**CORRESPONDENCE COVER SHEET  
WASTE PERMITS DIVISION  
TEXAS COMMISSION ON ENVIRONMENTAL QUALITY**

Date: April 25, 2019  
 Facility Name: City of Kingsville Landfill  
 Permit or Registration No.: MSW 235-C

Re: City of Kingsville Landfill – Kleberg County  
Municipal Solid Waste (MSW) - Permit No. 235C  
Permit Amendment Application – Notice of Deficiency  
Tracking No. 23301130, 23458984, and 24040819; RN102334570/CN600674246

On behalf of the City of Kingsville and in response to the Texas Commission on Environmental Quality's (TCEQ) March 27, 2019 Notice of Deficiency (NOD) letter, we hereby submit the enclosed response regarding the Permit Amendment Application for the above referenced MSW facility.

FIGURE:  
III.3-1

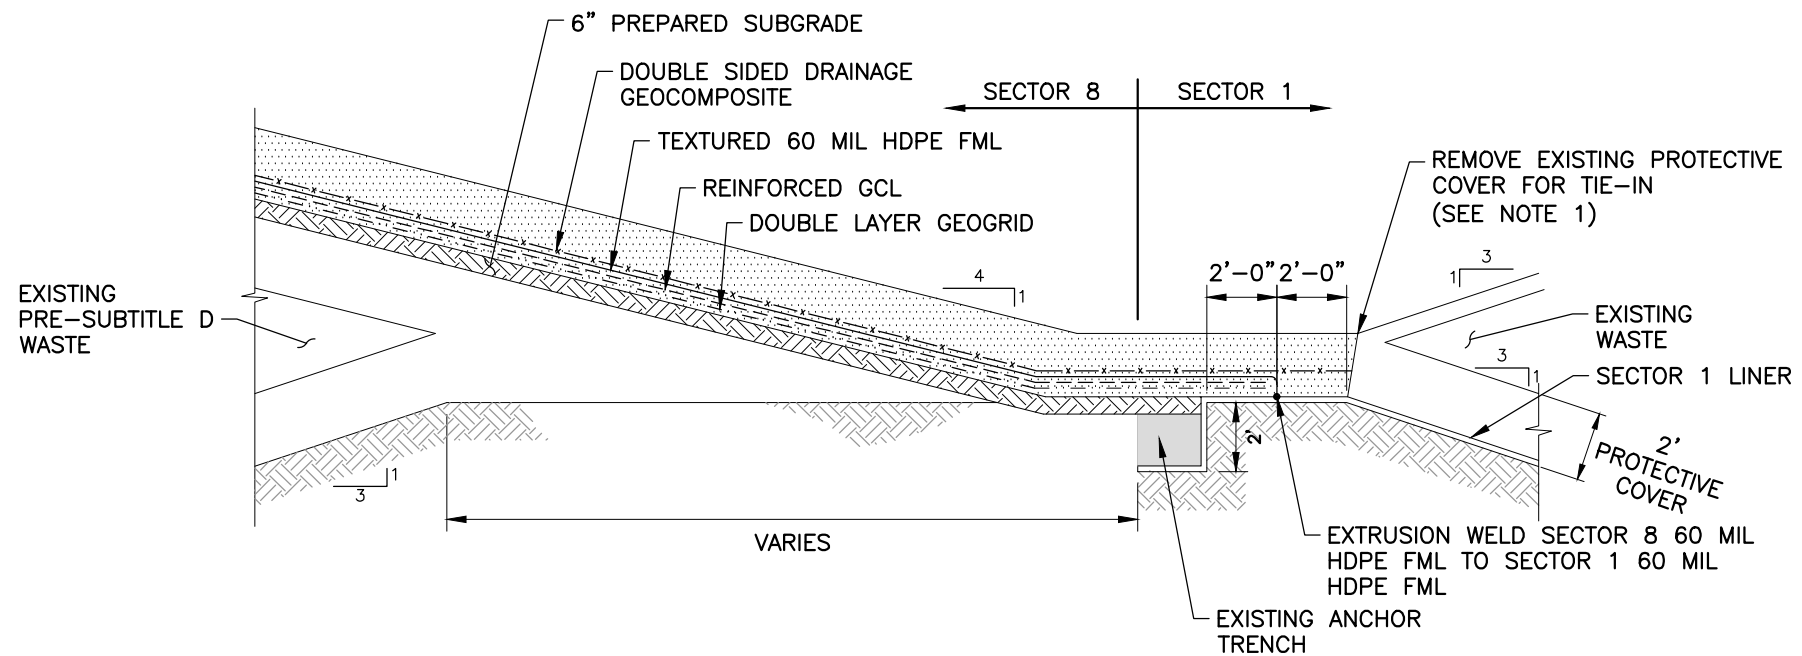
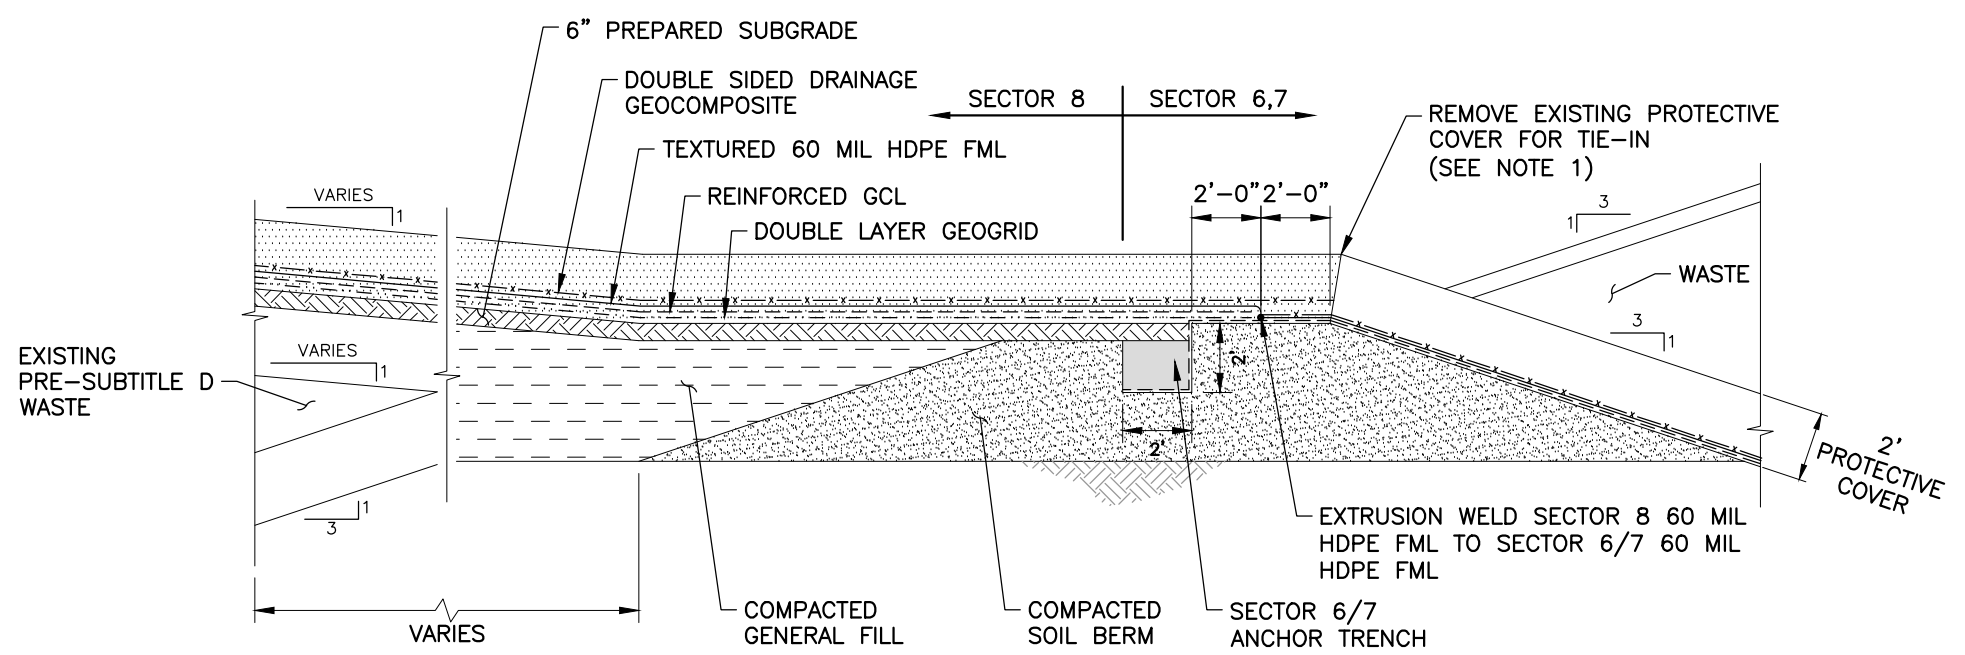
T42	684	Part III	330.453(d)(1)	Att 5	Inconsistent	Revise Att. 3, Fig. III.3-1 to show the topsoil layer and indicate its thickness.	Att. 3, Fig. III.3-1 has been revised to show the topsoil layer and indicate its thickness.
T43	694	Part III	330.457(d)(1)	Att 5	Incomplete	Provide Section 2.5 in Part III, Att. 5, pg 4, as mentioned in NOD1 response, and revise the Contents of Part III, Att. 5 accordingly.	Section 2.5 Alternate Composite Final Cover Design Demonstration as mentioned in NOD1 response has been included in Part III, Attachment 5, p.g.-4. The Contents, Part III, Attachment 5, p.g.i, Section 2 Alternate Liner Demonstration Methods has been revised accordingly.
T44	695	Part III	330.457(d)(2)	Att 5	Incomplete	See NOD comment T46 above.	Section 2.5 Alternate Composite Final Cover Design Demonstration as mentioned in NOD1 response has been included in Part III, Attachment 5, p.g.-4. The Contents, Part III, Attachment 5, p.g.i, Section 2 Alternate Liner Demonstration Methods has been revised accordingly.

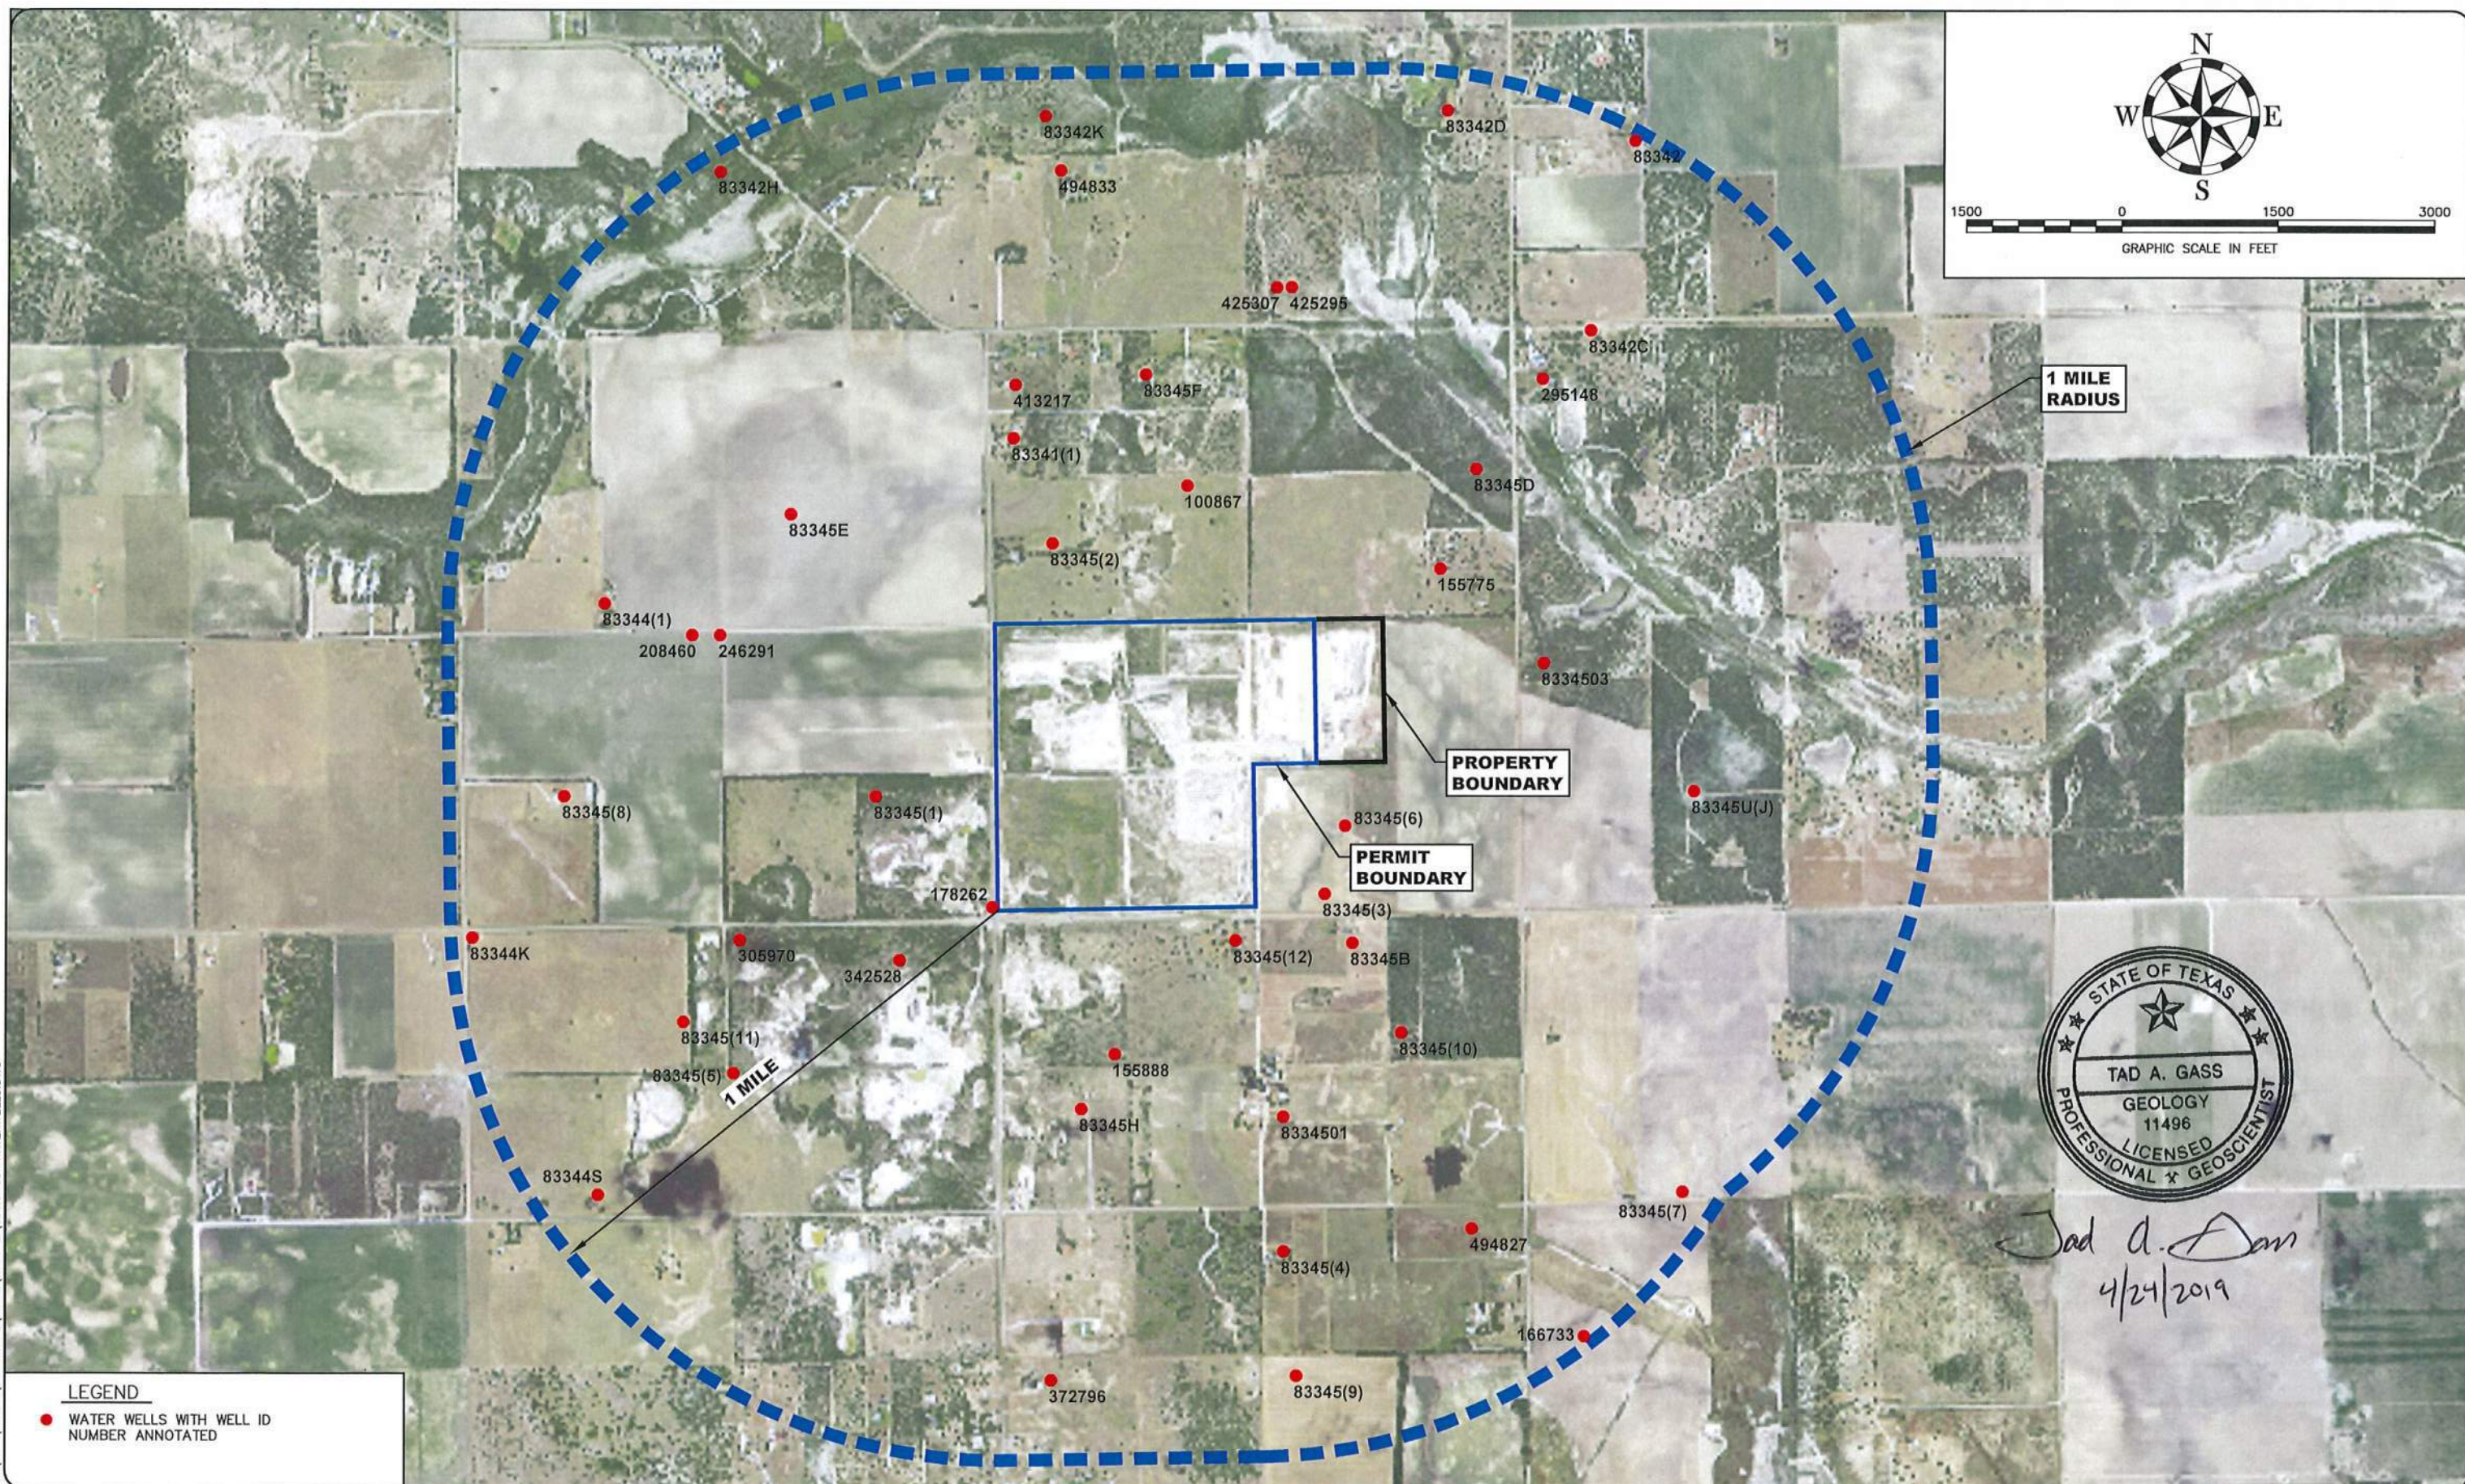
NT28	488	Part III	330.63(e)(3)(J)	Att 4, App 1: Sec 4.4, p. 37; Fig 4.15, p. 46; App J, p. 584-629	Incomplete	Provide a figure showing the locations of the water wells listed in Att. 6 to Att. 4.	Figure III.4-6-1 has been provided within Part III, Attachment 4, Attachment 6 showing the locations of the water wells.
T29	490	Part III	330.63(e)(4)(A)	Att 4, App 1, Sec 5.0, p. 48-55; and App 3, Sec 2, p. 4	Incomplete	Acknowledge in Sec. 1.4 that the drilled locations of borings B-32, 33, 34, 35, and 38 deviated from locations specified in the soil boring plan (March 29, 2016), explain why and how much they deviated, and how the investigator compensated.	"Locations of borings B-32, B-33, B-34, B-35, B-38 and B-40 deviated from locations specified in the soil boring plan due to boring locations being unknowingly moved from original locations during installation. These deviations were identified when the boring locations were surveyed. The distance of boring location deviation varied from approximately 90 feet in B-35 to approximately 440 feet in B-33. With the information obtained during previous subsurface investigations, these discrepancies did not affect the ability to obtain the needed information identified in 30 TAC §330.63(e)(4)(A)." This statement has been added to Sec. 1.4 of Part III, Attachment 4, on page 4.
